**Flood Control Project Maintenance
Levee Inspections**

Fall 2018 Levee Maintenance Deficiency Summary Report

**Flood Control Project Maintenance
Levee Inspections****LMA District Cover Sheet****Fall 2018 Levee Inspection Results****Reclamation District No. 0341 Sherman Island**

Reclamation District No. 0341 Sherman Island

Photo 1 of 3 : UCIP_FA_2018_52254_37654.jpg

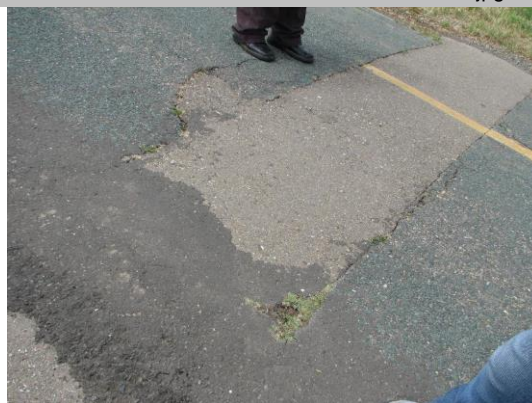
Cut along pipe alignment--unknown repair or maintenance date.

Photo 2 of 3 : UCIP_FA_2018_22258_37930.jpg

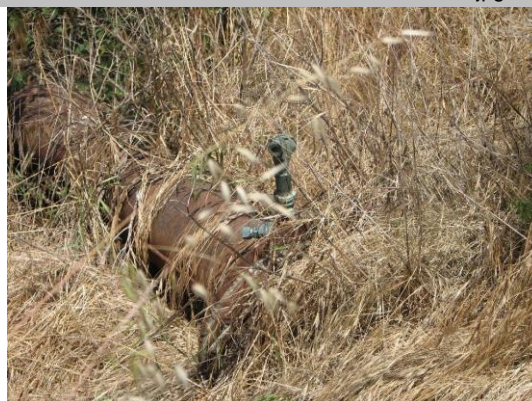
Air vent located on waterward side.

Photo 2 of 3 : UCIP_FA_2018_22263_37961.jpg

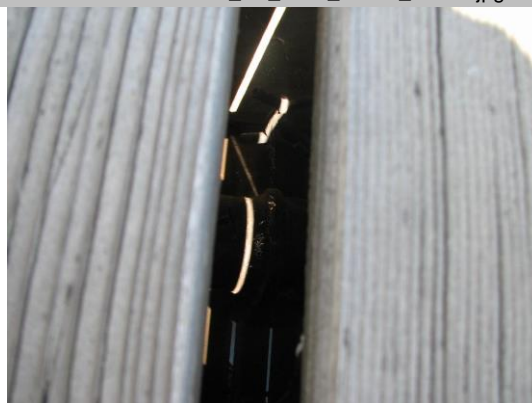
Unable to confirm number of pipes.

Photo 2 of 3 : UCIP_FA_2018_22264_37964.jpg

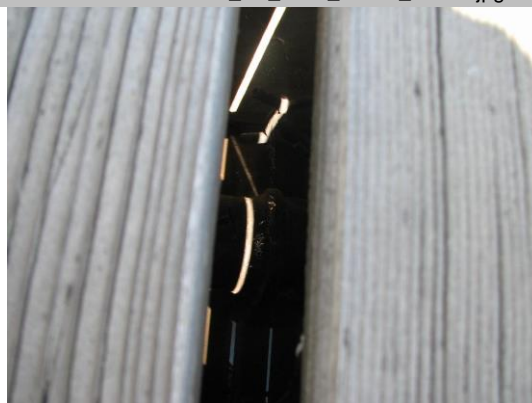
Unable to confirm the number of pipe through section of levee.
